SANCTUARY OF PEACE RESIDENTIAL COMMUNITY PUD DEVELOPMENT PLAN / PRELIMINARY PLAT

DEVELOPMENT PLAN COVER SHEET

PUDSP-19-002

PUDSP V_2 redlines.pdf Markup Summary 10-16-2019

**DEVELOPMENT PLAN
SITE PLAN (OVERALL)**

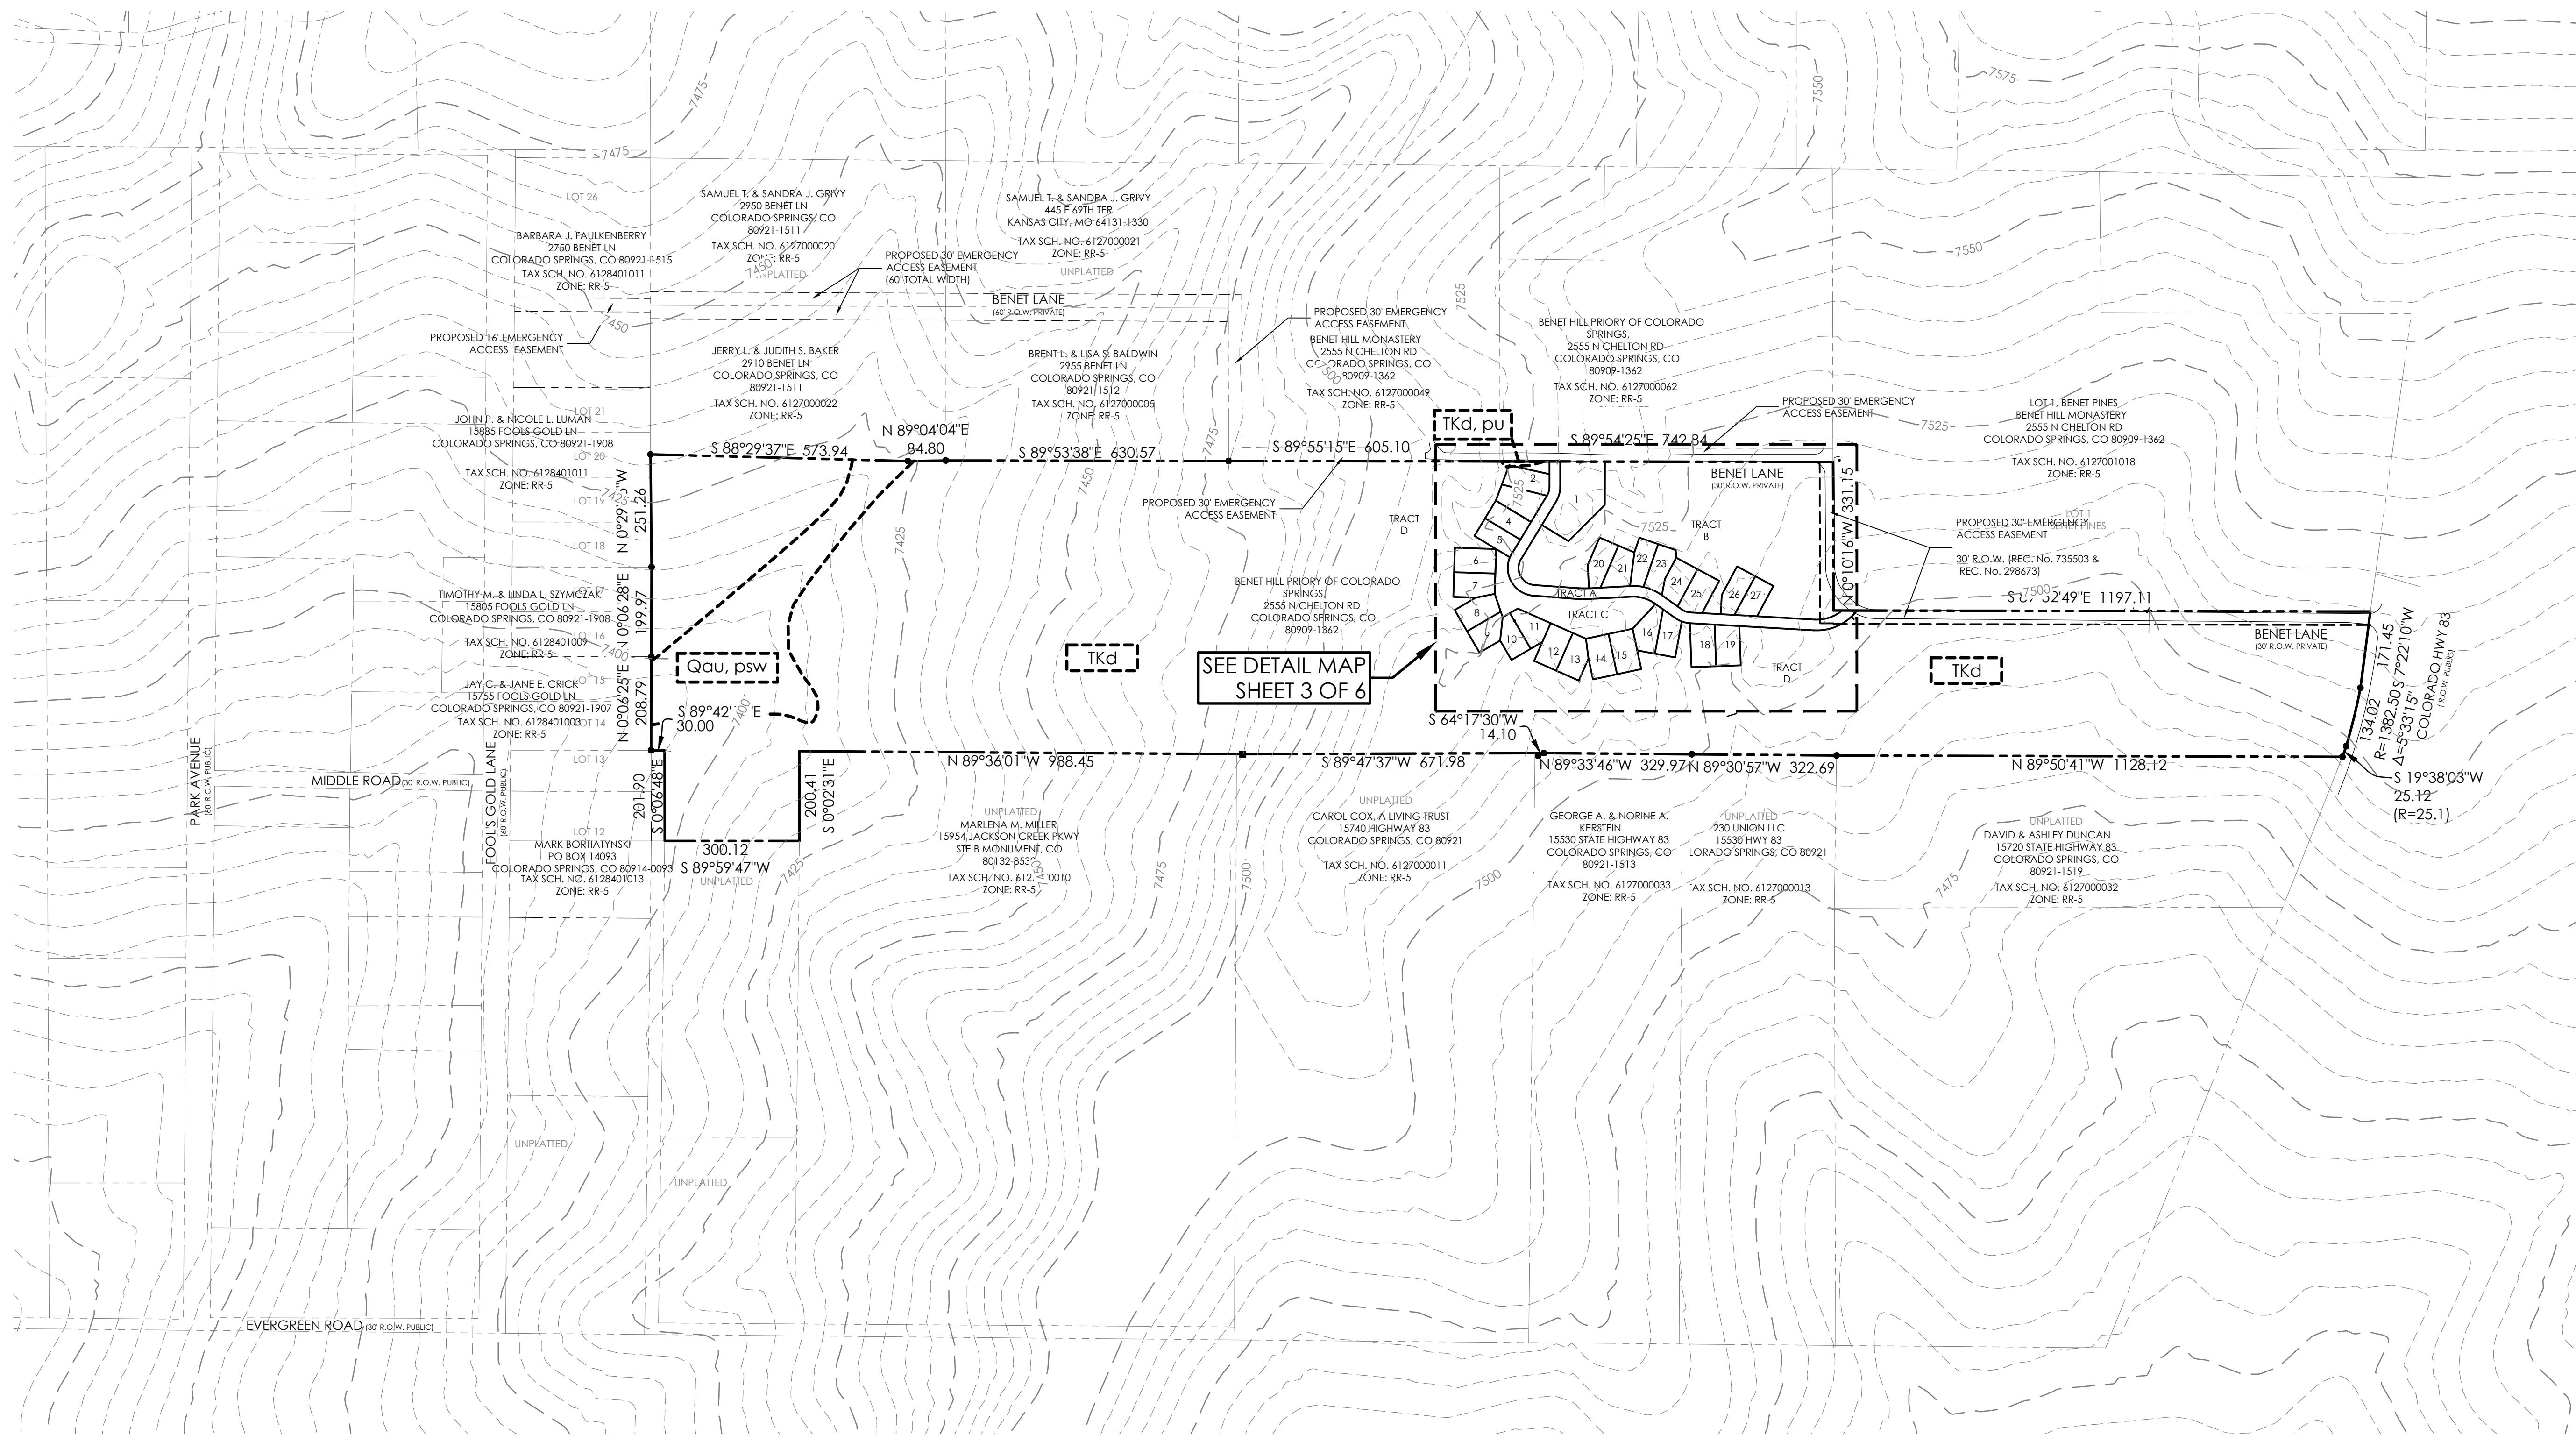
this has no standards for the community center... provide them.

do you need to add pump house or water treatment, as an allowed use? where is it and our there setbacks or standards?

1. you must provide a numeric value; counter staff will not calculate based on a drawing. Provide numeric values.

Front yard setback is measured to structure so is that 15'? State if so...face of house is not a measurable numeric value...

Font yard? State Numeric Value or State behind Principle Structure

you say on the PUD garages are allowed detached; provide the standards.

Add this use above to be included in the Community Center or is it stand alone?

What Sheet is the landscape plan depicted on? 6

so how many bedrooms are allowed in each of the systems? where does the community center fall into? hotel/motel rooms? Do you need a table to depict the info?

Add the gas providers

You need to add retaining walls to the development standards above as an allowance into the setbacks.

community center w/ hotel like rooms

Provide the maximum size and setbacks for detach garages in the dimensional standards (Development Standards)

is this the building size or the lot size?

community center with hotel rooms?

this is not really accurate because there is also a commercial component...So you need to account for the community center and hotel as the next line item..

Use the standard note: be specific comment not addressed from 1

DEVELOPMENT PLAN
SITE PLAN (DETAIL)

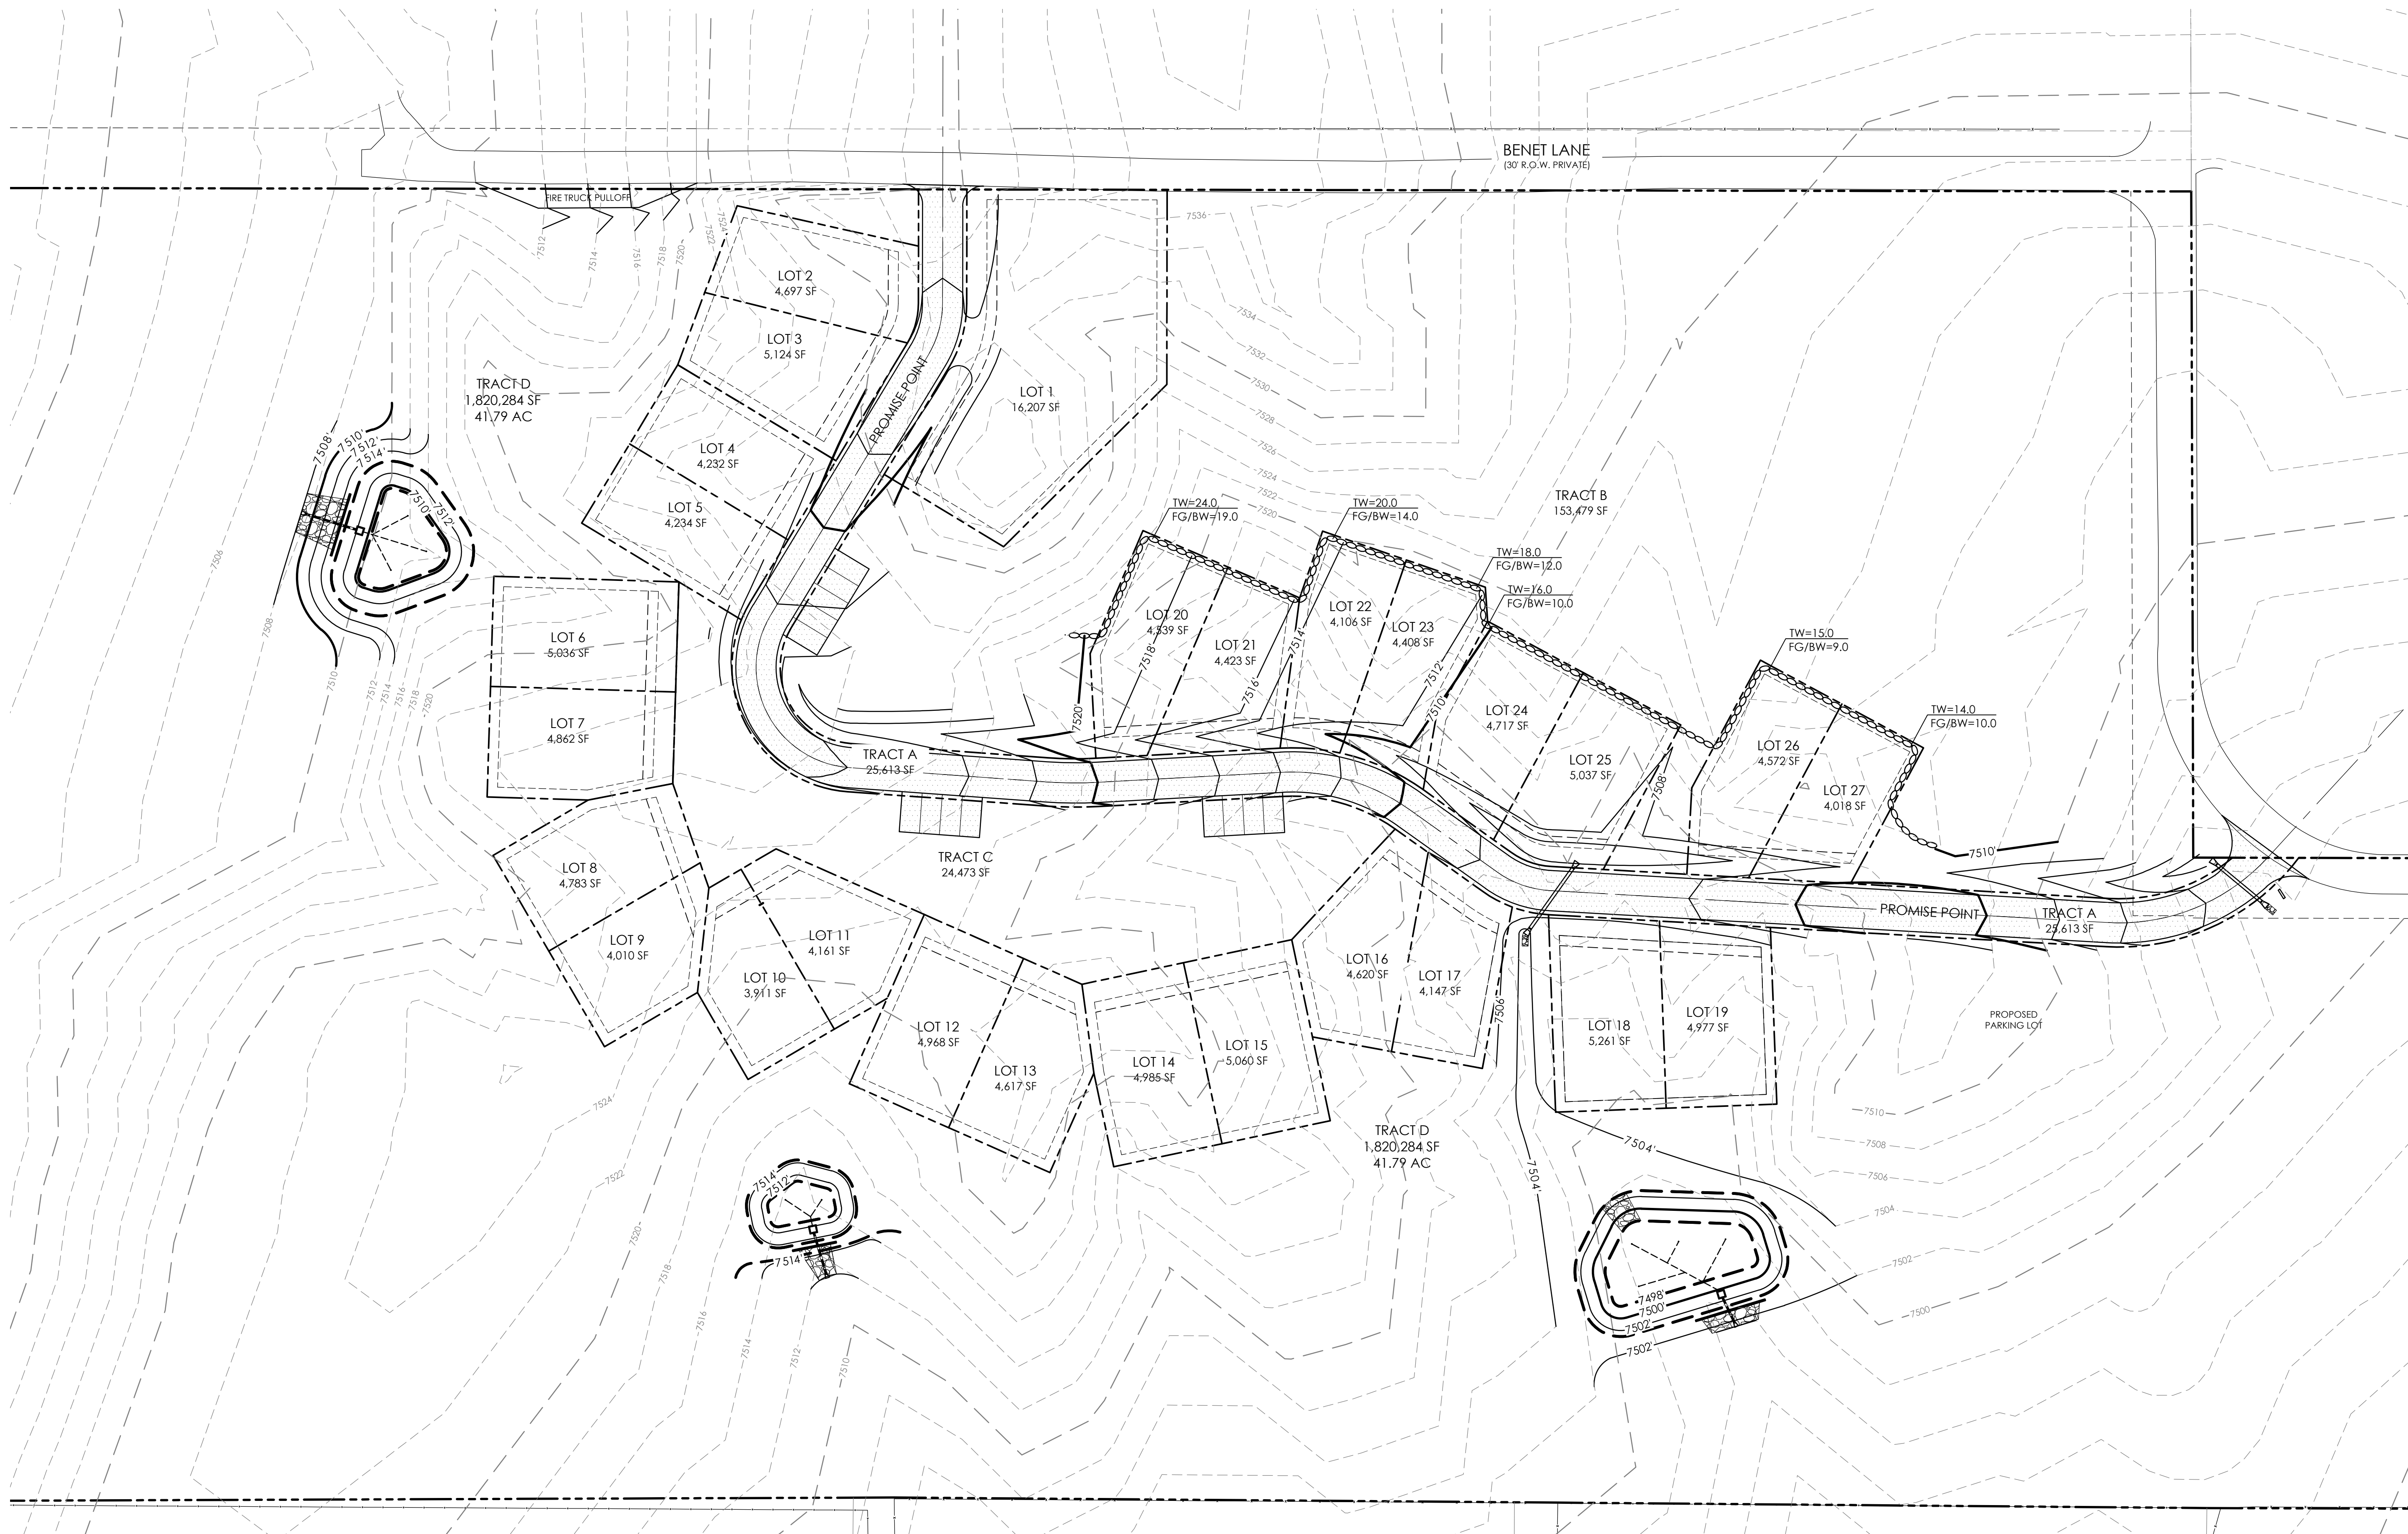
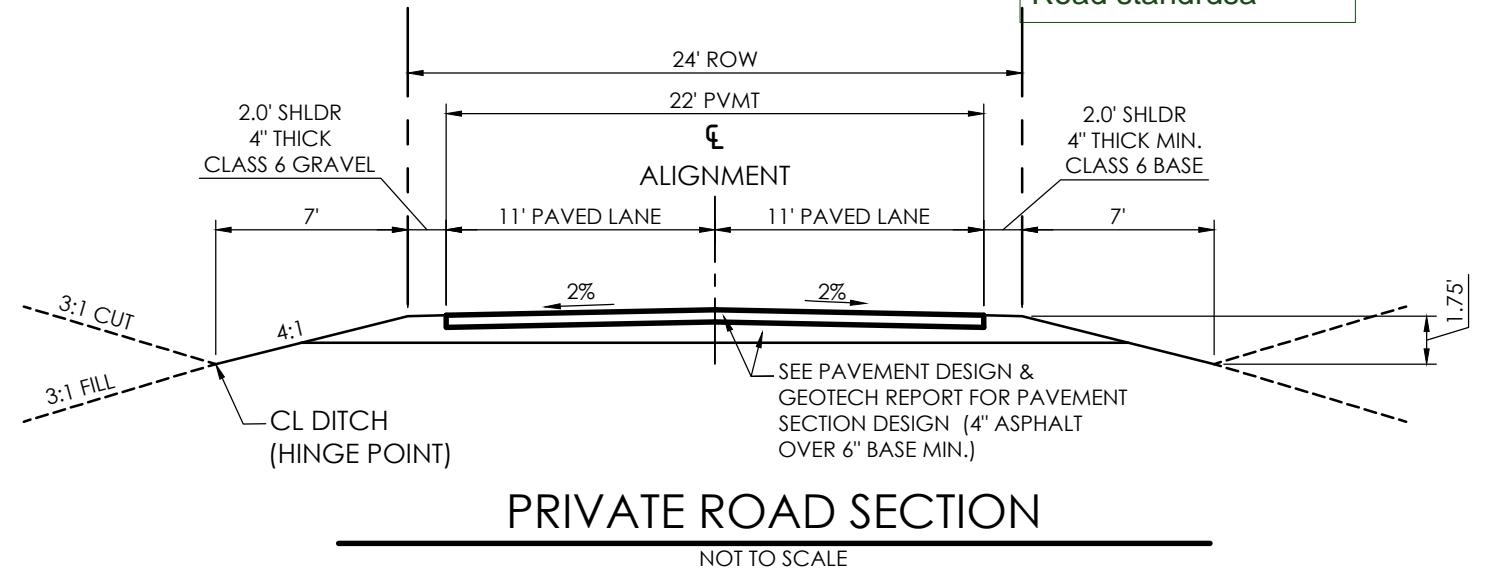
Application needs to have all the requirements for a PUD and preliminary plan on it. Review Chapter 4 and 7.8. Also review the checklist for each map and combine.

What are these lines? how far are they from the lot line?

each lots should front the private road; each lot should have physical access

where is the well? where are the septic systems and the easements.

these lots have no physical access to a roadway? lots 9 and 10 make little sense for access.... Where are the cars parked for each lot, driveways?

Why are the contours not extended to the edge of the property?

Where is the sidewalks and ADA requirements? Private roads are to be built to County Road standards

Call out the area that is described on page 8 of the Geology and Soils report as unstable due to the Benet Lane road cut. Additionally call out proposed mitigation for this area.
